Gorton Centrepoint

Proposed Ground Floor Plan (Comparative Analysis)

GCP-KMA-XX-XX-DR-A-7007

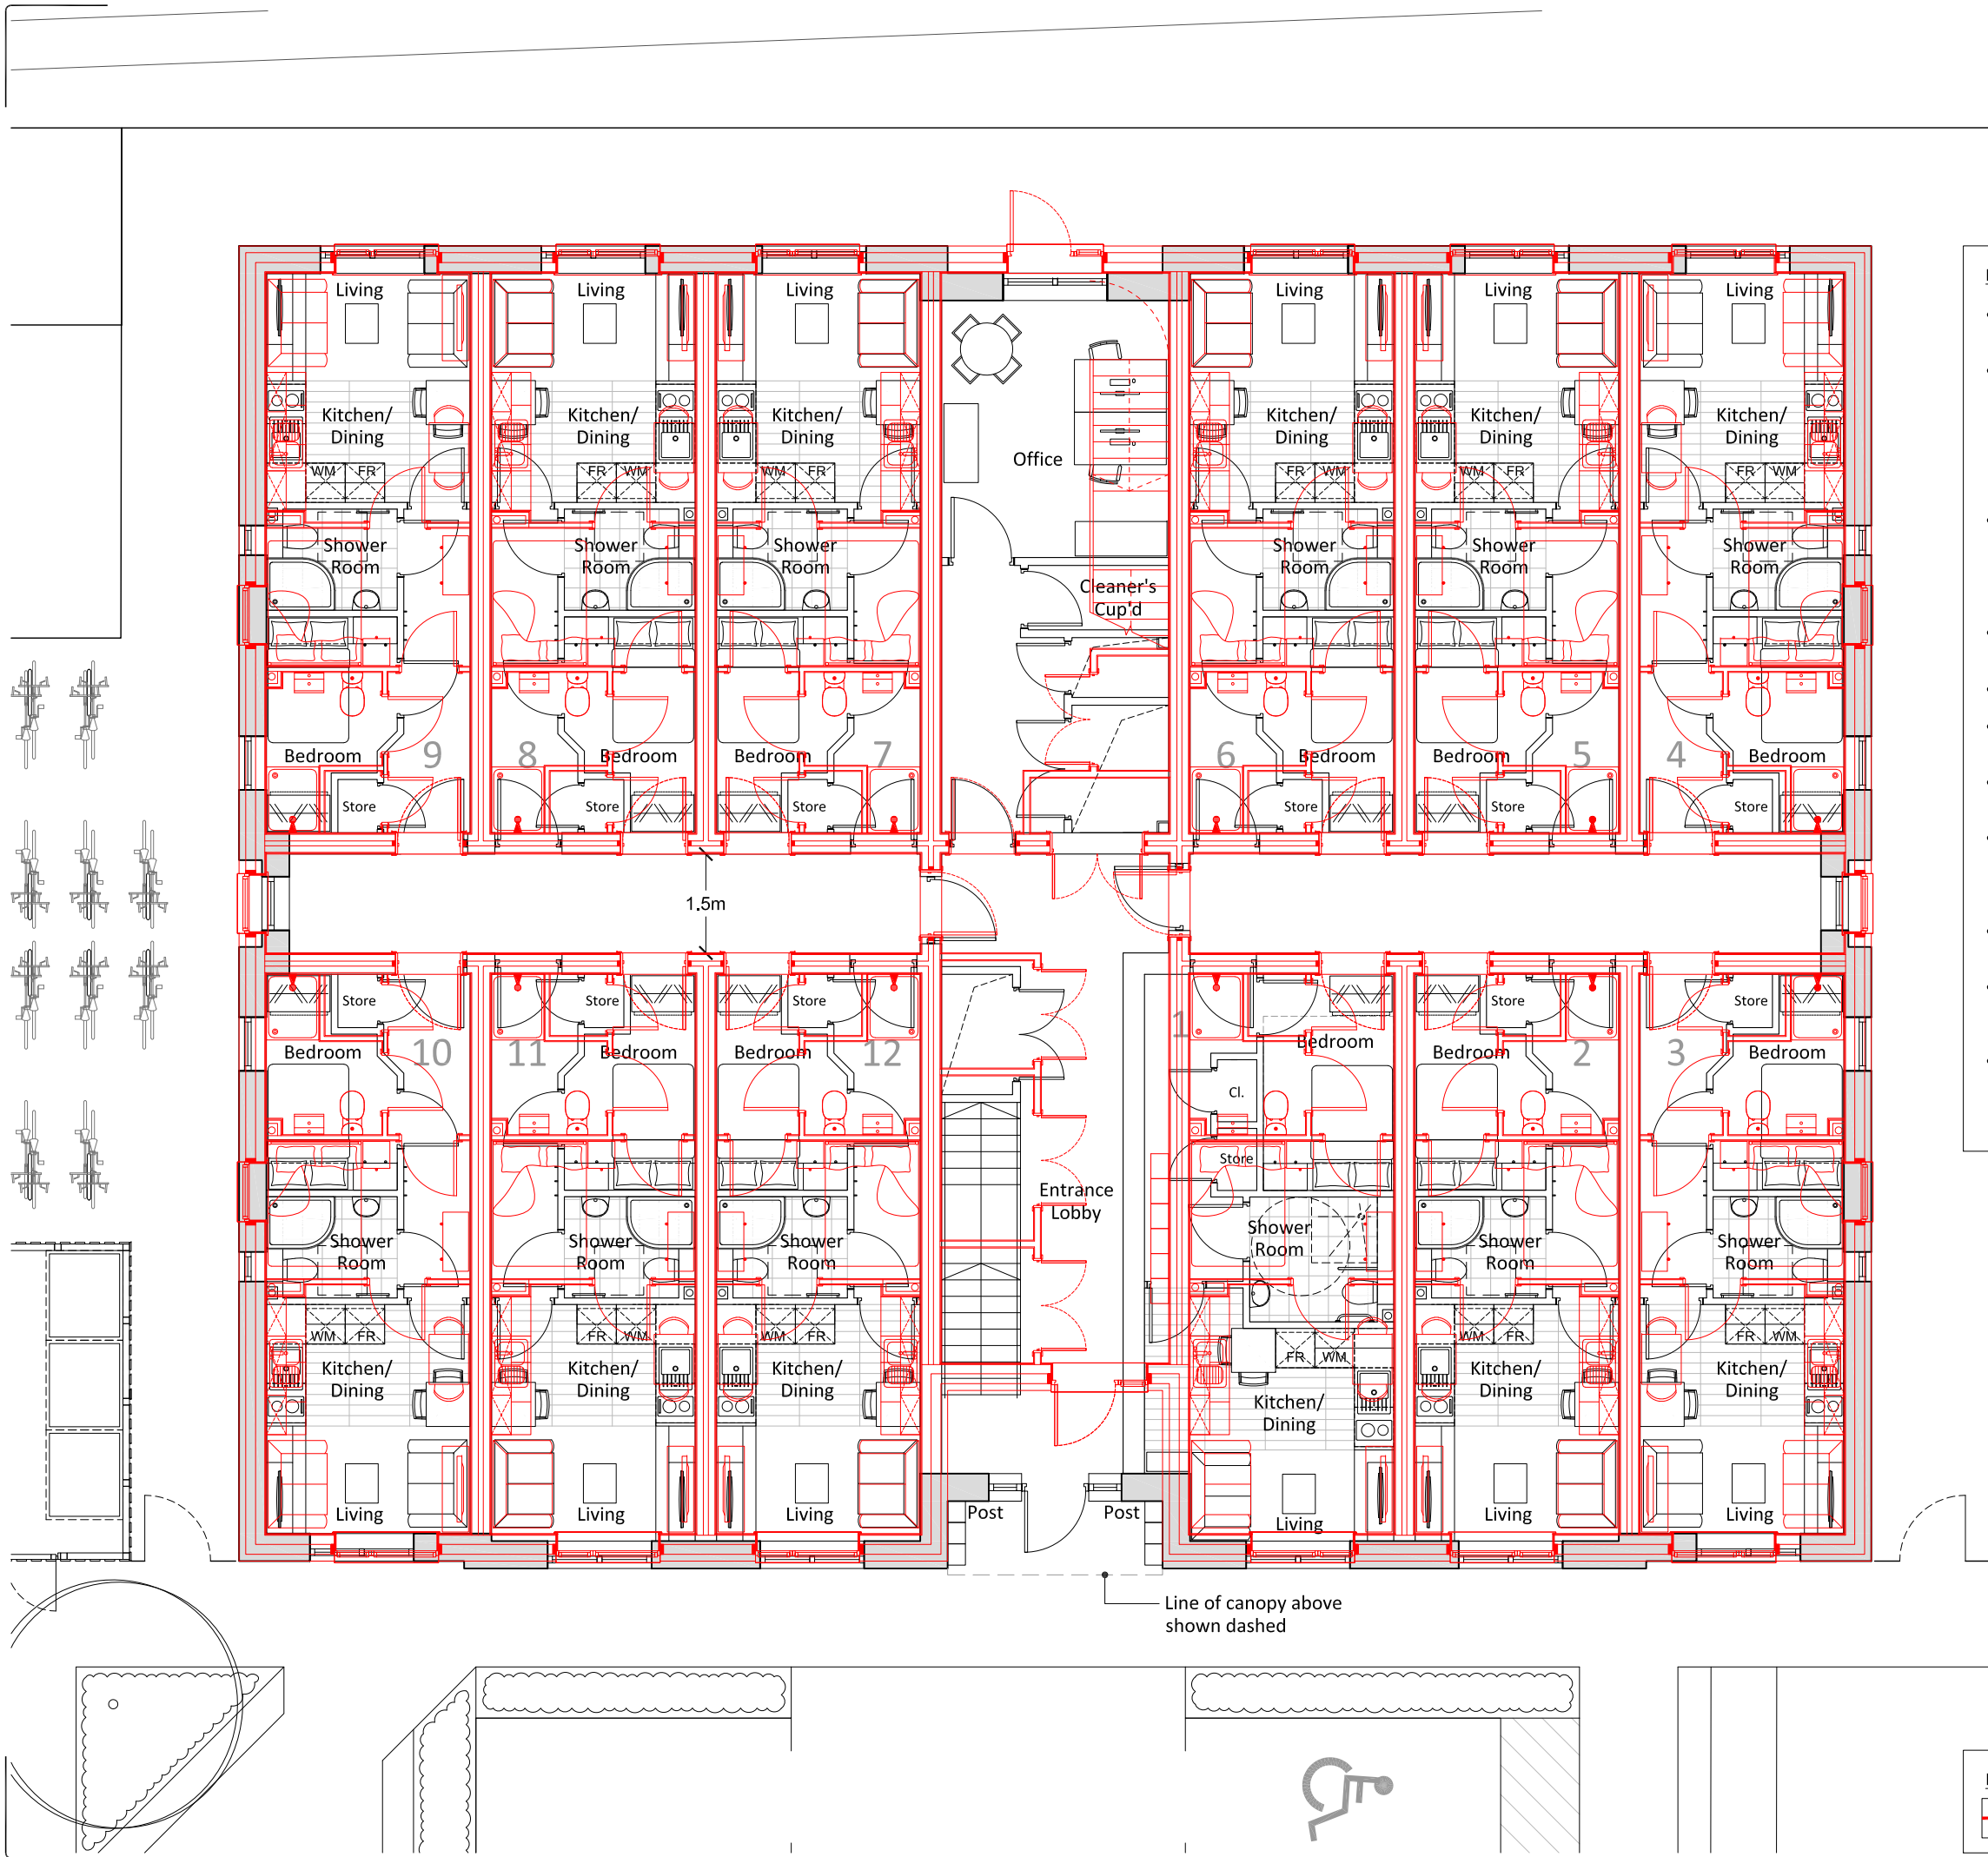
**PROPOSED BUILDING AMENDMENTS**

- 2no. (minimal) feature gable projections to be added to the principal elevation.
- The approved flat roof and parapet detail have been replaced with a traditional pitched roof. The proposed ridge height is to remain the same as the approved parapet, but the proposed (lower) eaves height shall reduce the overall visual mass of the building.

- A concealed plant area (securely accessed via the main stair) is located upon the proposed central flat roof section, to be hidden from view by the pitched roof returning front-to-back to form a visual barrier.

- The main entrance is to be pulled forward, but not beyond the approved building line/principal elevation.
- The main entrance is to include for a proposed canopy.

- All solar assisted heating panels are to be removed from the front and rear elevations.
- A PV array is now proposed to the south-facing roof to assist with energy generation.

- All Juliet balconies and associated doors to each apartment are to be replaced with larger openable windows on the front and rear elevations.
- Wall recesses and full-height glazing are to be added to the corridors within each gable end.

- Additional small windows are proposed within each gable end, with no overlooking issues to either the west or east.
- The proposed material palette is to match the adjacent GMYF building in terms of the proposed red facing bricks, artificial slate roof and glazing.
